To: Scott Rukke - Chief, Pipeline Safety
From: Gerrud Wallaert - Chief Operation Officer of RNG
Date: 1/20/2023
Re: 2022 Biogas Standard Inspection – Augean RNG (Insp. No. 8415)

Augean Overpressure Protection Calculation Worksheet

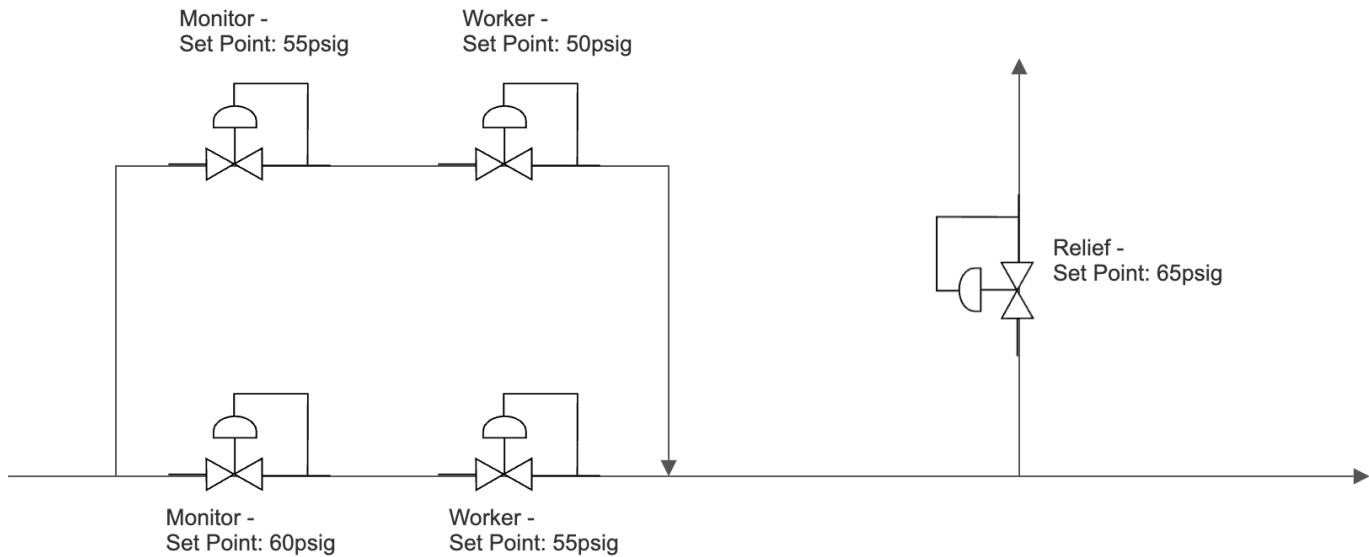
1. §192.201 – Required Capacity of Pressure Relieving and Limiting Stations

- a. Augean RNG currently does not have calculations verified by an engineering firm which support that our pressure limiting stations comply with CFR 192.201(a)(2)(i). After learning of this oversight Augean RNG utilized the Brightmark Manager, Pipeline O&M, to perform an initial analysis of the overpressure protection equipment to determine if the equipment is sufficiently sized to handle a failure. The initial analysis provided by this employee is attached below.

The main run has the working regulator set at 55psig, and the monitor at 60psig. The secondary run as the working regulator set at 50psig, and the monitor regulator set at 55psig. Below is a rough diagram of the system setup. Please note that the diagram is for demonstrative purposes only and that items may be installed differently, such as the sensing lines, then they appear in the drawing.

Knowing we can use the simplified gas sizing equation; we can determine that all four (4) of the workers and monitors will have the same capacity, regardless of the set point. The calculated capacity of a regulator is below and, because OPP is the main concern, is calculated using the maximum allowable operating pressure of the supplier. This confirms that each of the monitor regulators are sufficiently sized to handle the full inlet pressure and the estimated load of 25.5 mscfh in the event of a complete failure of the worker regulator. This is true both when the system is operating at 60psig or, assuming the set points are appropriate, at 125psig.

Since the relief valve will be set between 60psig and 125psig, the purple spring will be used to consider the build-up to maximum capacity. For this spring, the buildup is 1.0psig. Using the simplified gas sizing equation, we want to confirm that this relief valve can relieve the full capacity of both regulator runs. The total relief capacity must be over **320 mscfh**.

Knowing that the capacity of the relief valve is 502 mscfh it is confirmed that the relief valve is appropriately sized to handle the full capacity. Additionally, since the buildup to maximum capacity with the purple spring is 1.0psig, if we adjusted this relief valve in accordance with the current design up to MAOP, the hypothetical set point would be 130psig, with a maximum downstream pressure of 131psig. This would be well below the MAOP plus allowable buildup on the system.

Currently, with the relief valve set at 65psig the maximum pressure the downstream system would see in the event of all four regulators failing would be 66psig, well below the MAOP plus allowable buildup.
